FERNLEA SUBDIVISION

APPLICATION NUMBER 11 DATE May 1, 2003

APPLICANT Fernlea Subdivision

REQUEST Subdivision

FERNLEA SUBDIVISION

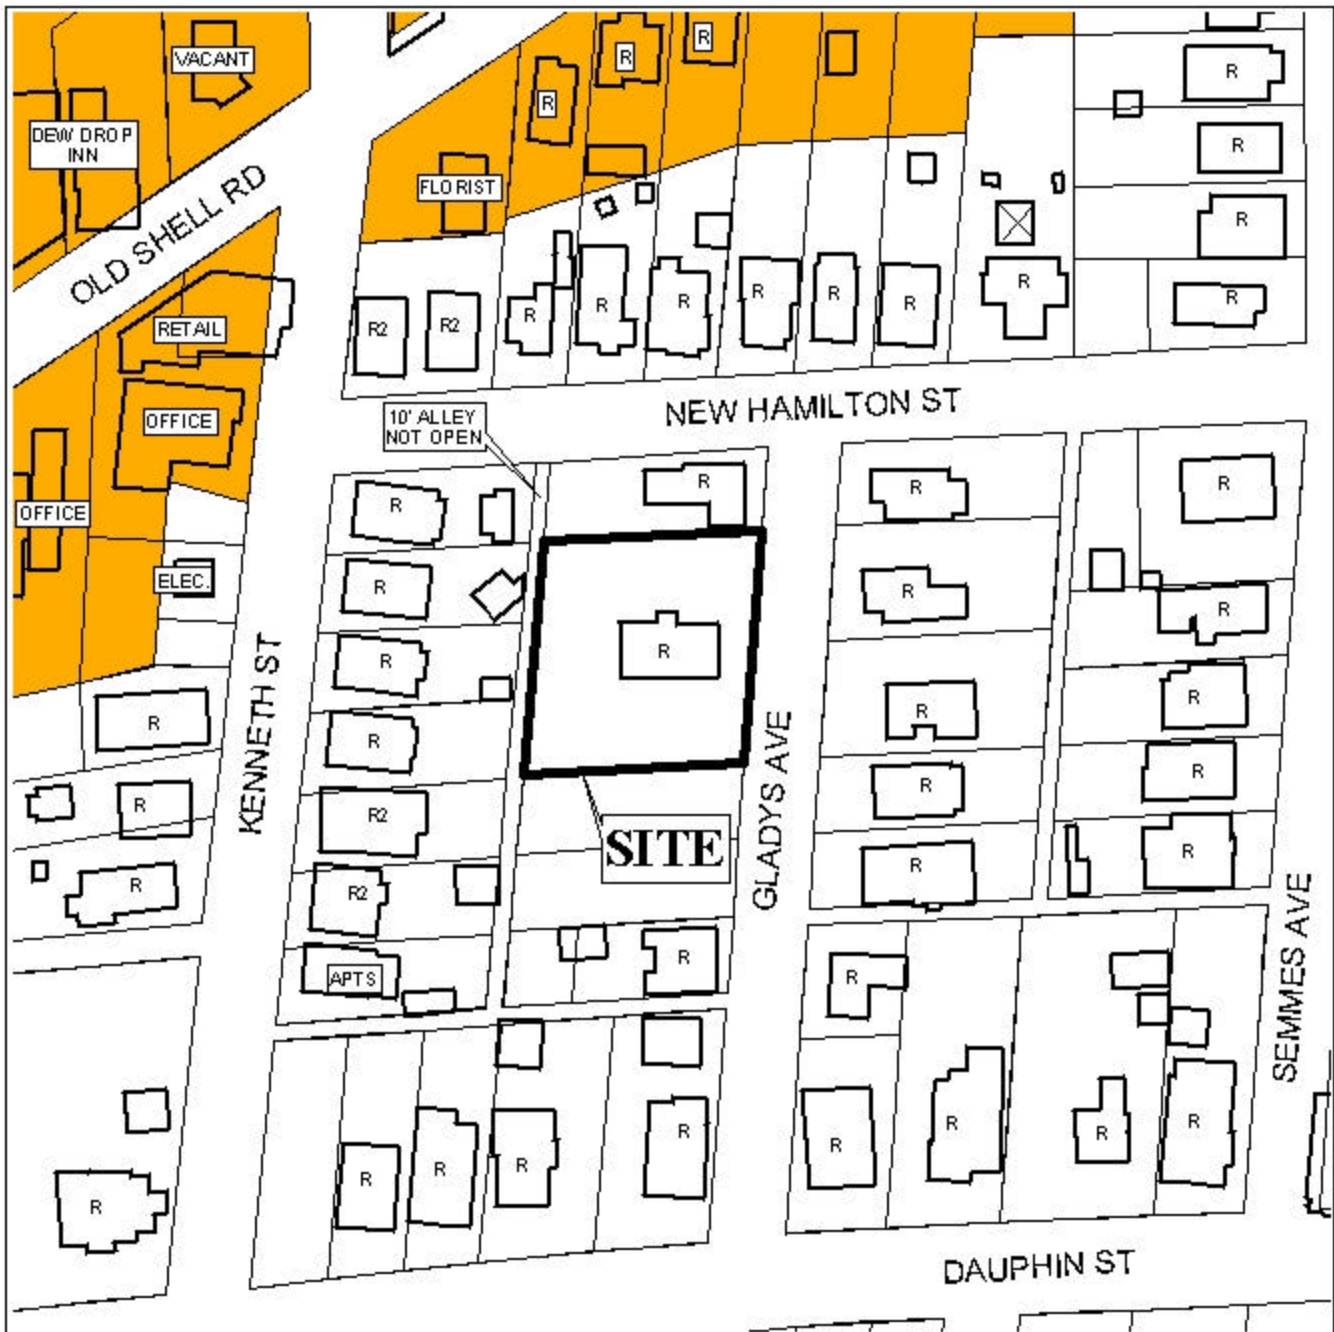
As illustrated on the Vicinity Map, a 10' alley [unopened] is to the rear of the proposed subdivision; therefore, the placement of a note on the final plat stating that site is denied direct access to the alley should be required.

The twenty-five foot minimum building setback line is not shown but would be required on the final plat.

The plat meets the minimum requirements of the Subdivision Regulations and is recommended for Tentative Approval subject to the following conditions: 1) the placement of a note on the final plat stating that the site is denied direct access to the alley; and 2) the placement of the twenty-five foot minimum building setback line on the final plat.
